ADDENDUM NO. 2 TO PROJECT NO. 42535

PROVIDE ELECTRIC UPGRADE FOR FEEDERS, TRANSFORMERS, AND SWITCHGEAR SITEWIDE

GREENHAVEN CORRECTIONAL FACILITY
ROUTE 216
STORMVILLE, N.Y. 12582

February 21, 2013

PROJECT NO:	SCALE:
111109.A0	AS SHOWN
DATE: 02/19/13	DWG NO: SK-EP2.21B-1

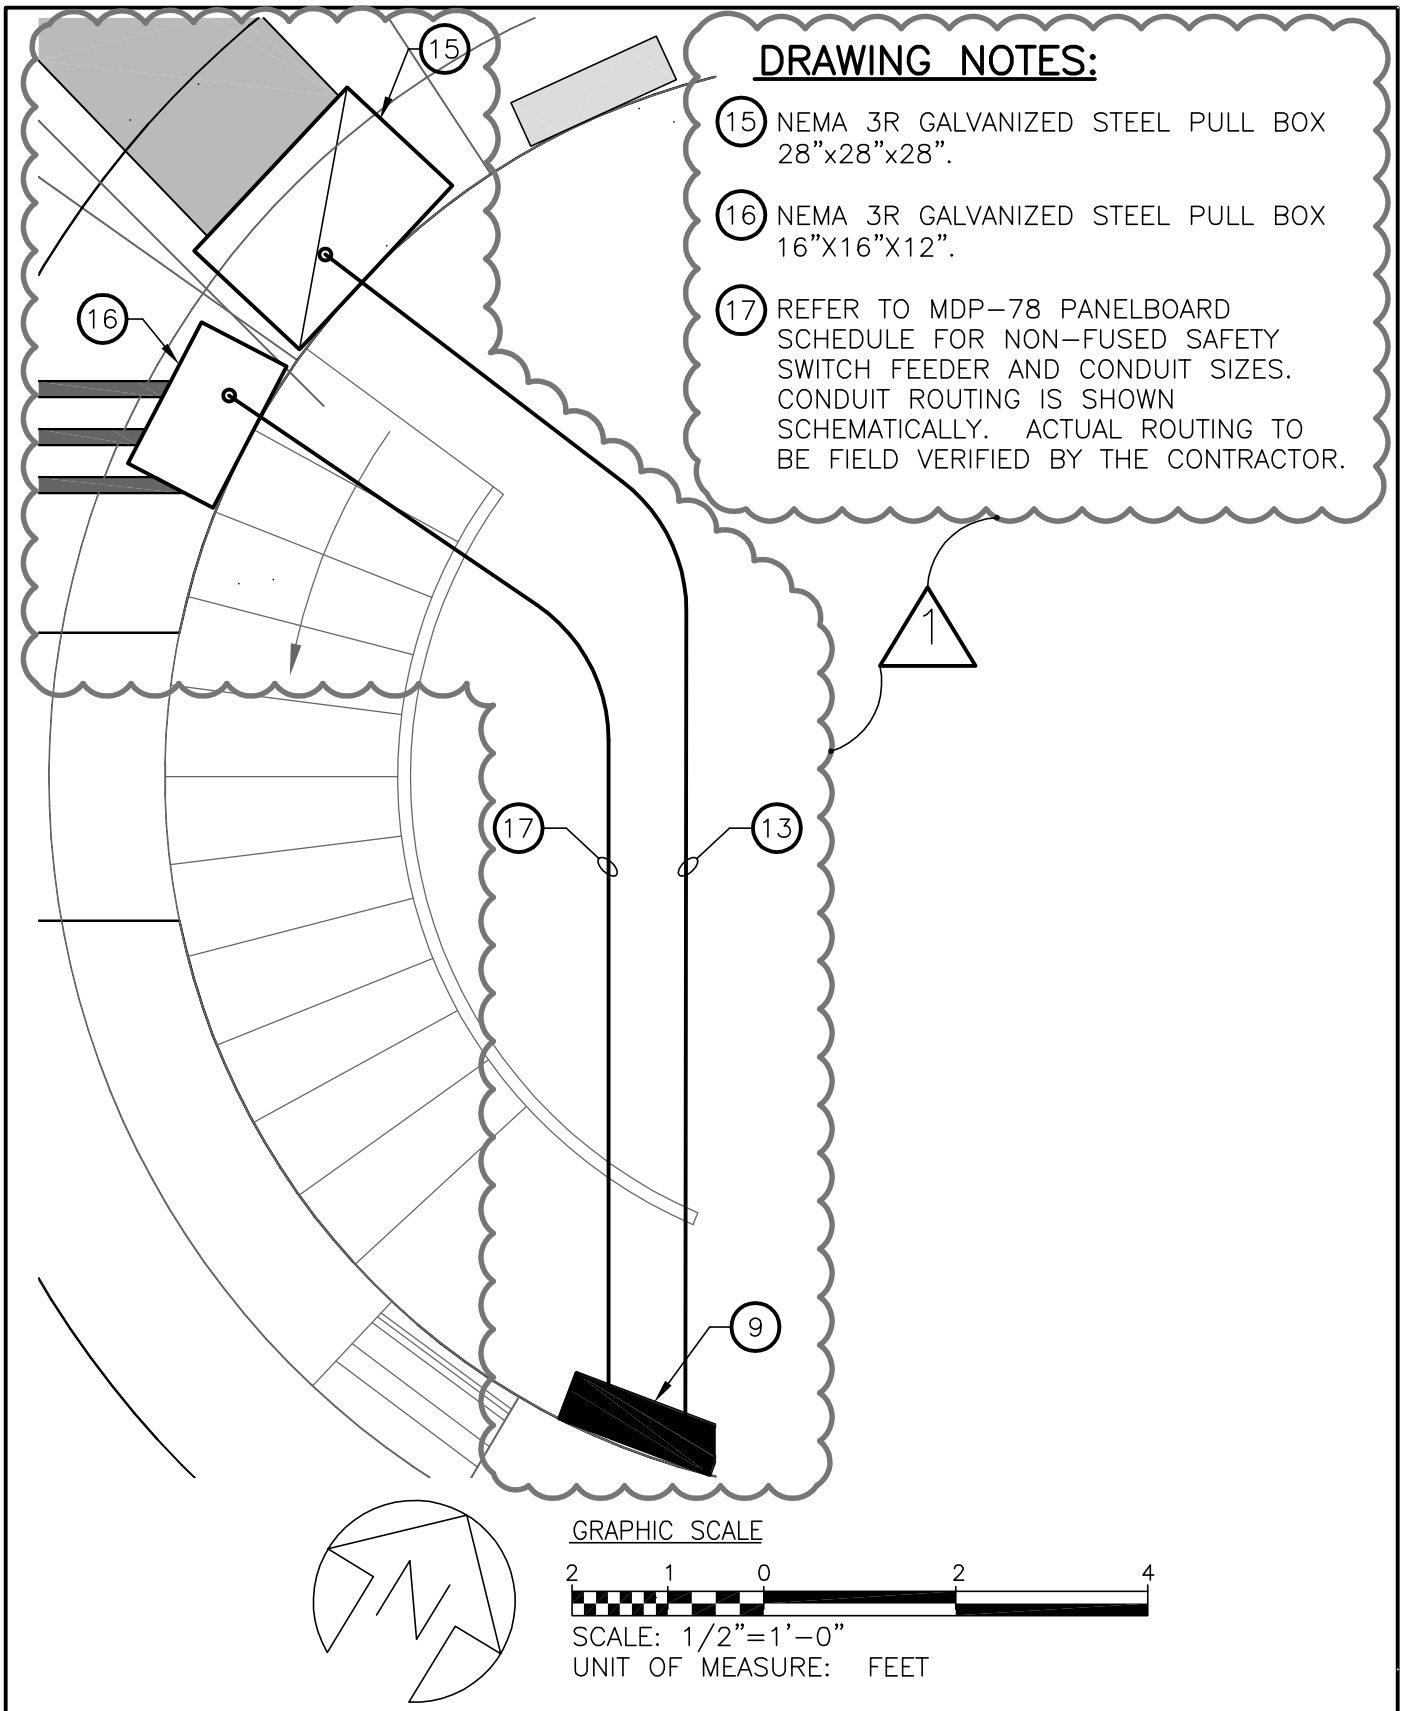
15. Drawing EP2.21B:
    a. Revise "GREEN HAVEN C.F. – GUARD TOWER No. 5 – NEW WORK". See accompanying sketch SK-EP2.21.B-1.

PROJECT NO:	SCALE:
111109.A0	AS SHOWN
DATE: 02/19/13	DWG NO: SK-M1.12-1

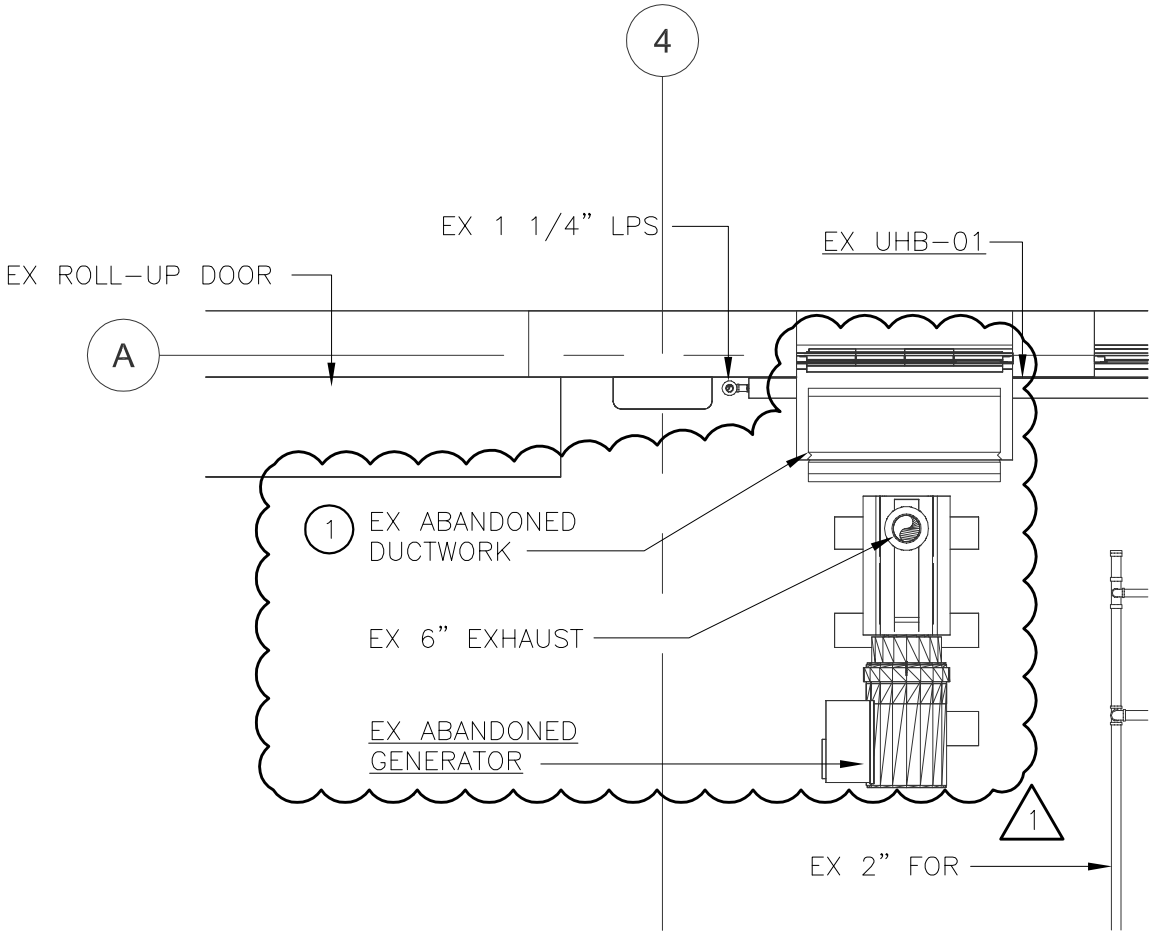
1. Drawing M1.12:
   a. Change Match line callout to read "MATCH LINE (NO CONTINUATION)."
   b. Existing abandoned generator removal scope was modified. See accompanying Sketch SK-M1.12-1.

1. ABANDONED GENERATOR AND ASSOCIATED DUCTWORK TO BE REMOVED BY 'E' CONTRACTOR, 'H' CONTRACTOR SHALL PROVIDE 20 GA GALVANIZED 4'-0"L x 4'-6"W STEEL BLANK OFF PANEL WITH STIFFENING ANGLES TO TEMPORARILY ENCLOSE WALL PENETRATION.

SHEET TITLE:
ENGINE ROOM – UPPER LEVEL ELEV. 437.0' – REMOVALS – PH 1

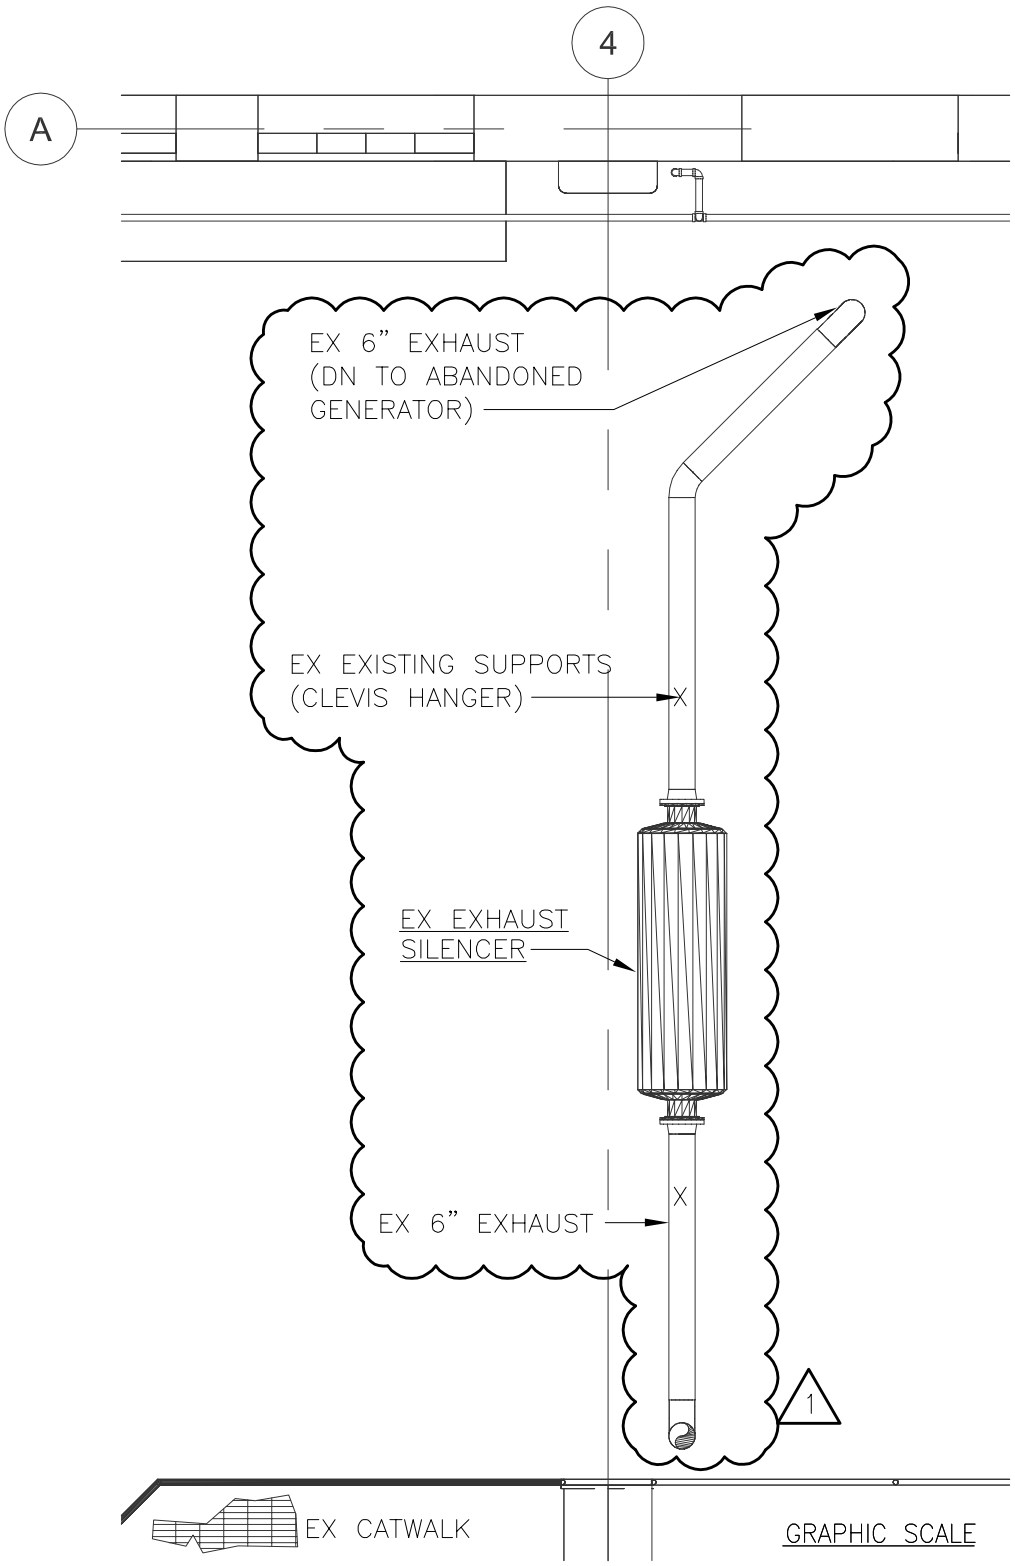
2. Drawing M1.13:
   a. Existing abandoned generator exhaust pipe and silencer removal scope was modified. See accompanying Sketch SK-M1.13-1.
